SITE PLAN SUBCOMMITTEE OF THE PLANNING AND ZONING COMMISSION

September 6, 2016 - Tuesday

- I. Welcome To Attendees And Roll Call Of Commission Members
- II. Review Tonight's Agenda/Questions Or Comments
- III. P.Z. 12 & 13-15 Villages At Brightleaf
Review and discussion of the Site Development Plan (SDP) and related items; R-3 10,000 square foot Residence District (Town Center "Neighborhood General District" and "Neighborhood Edge District"), with a Planned Residential Development Overlay District (PRD); north side of State Route 100, east of State Route 109 (**Ward Five**)

The Villages at Bright Leaf

Job Number: 14-04-138
 Date: Aug. 19, 2016
 Designed: MF
 Drawn: SL
 Checked: SL
 Sheet: 3.1
 SDP

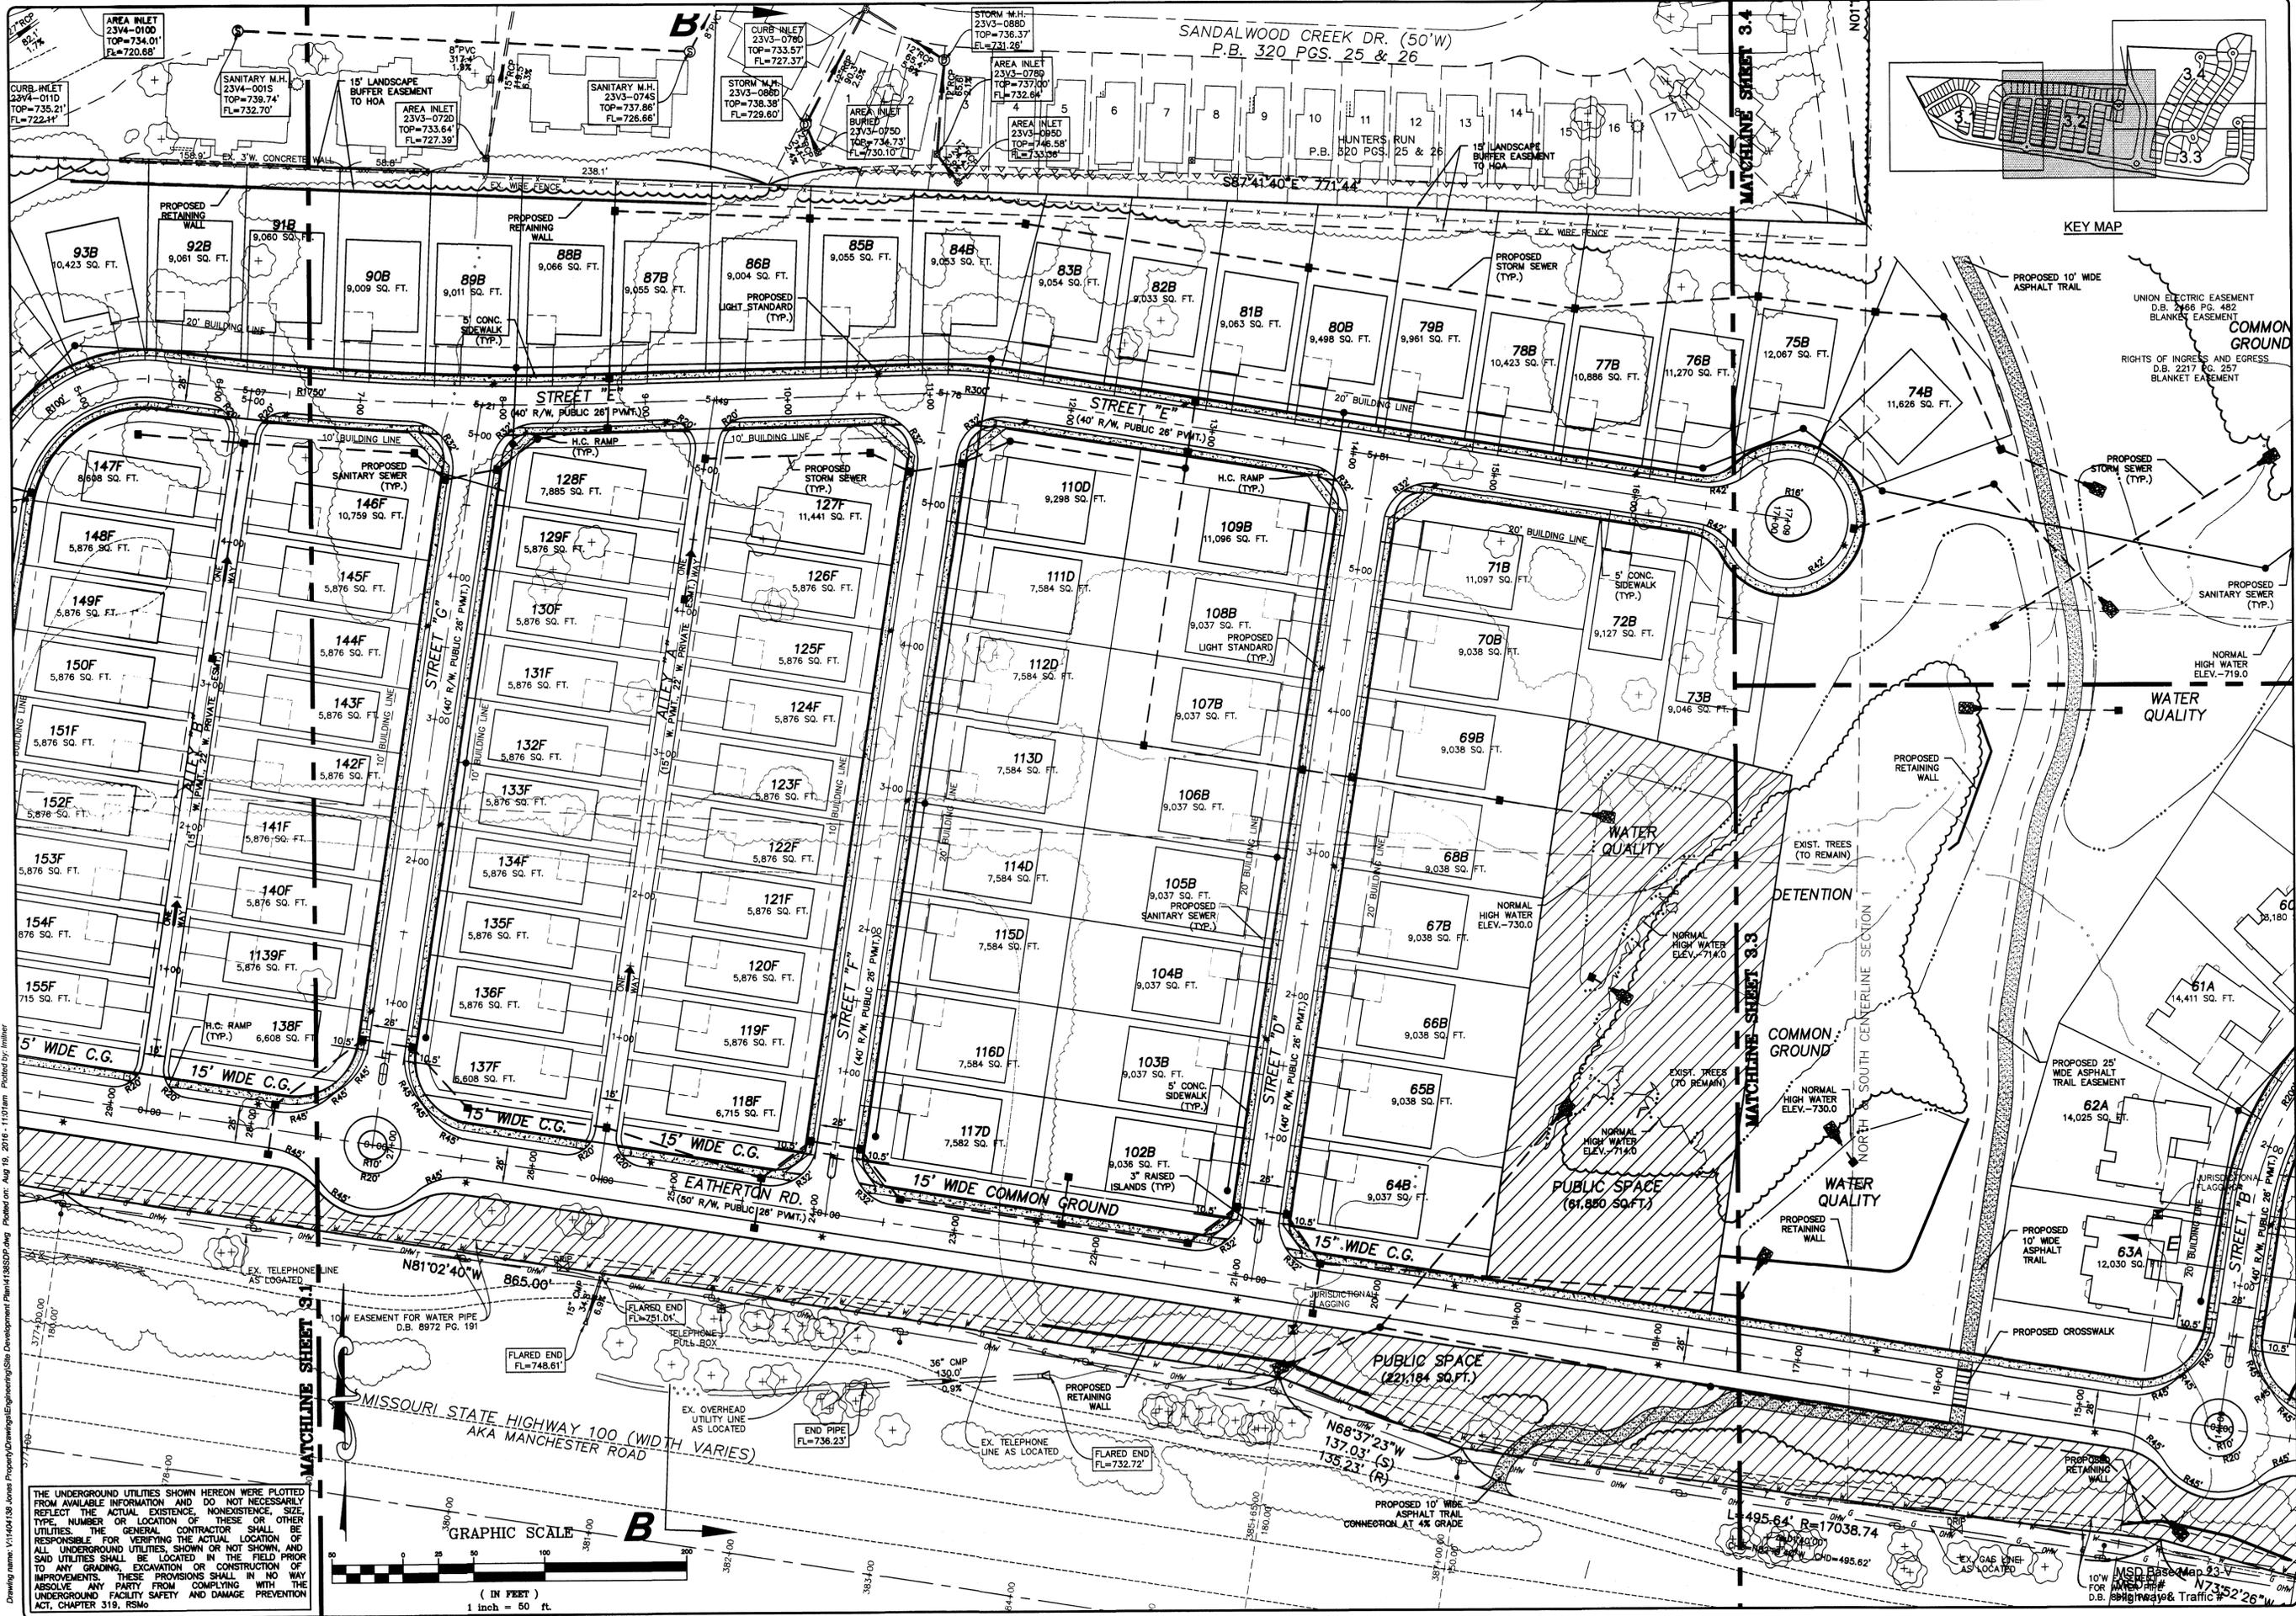
36. Please complete the public space table on Sheet 3.1.
37. Please extend all proposed sidewalks into and around the cul-de-sac bulbs throughout the development area.
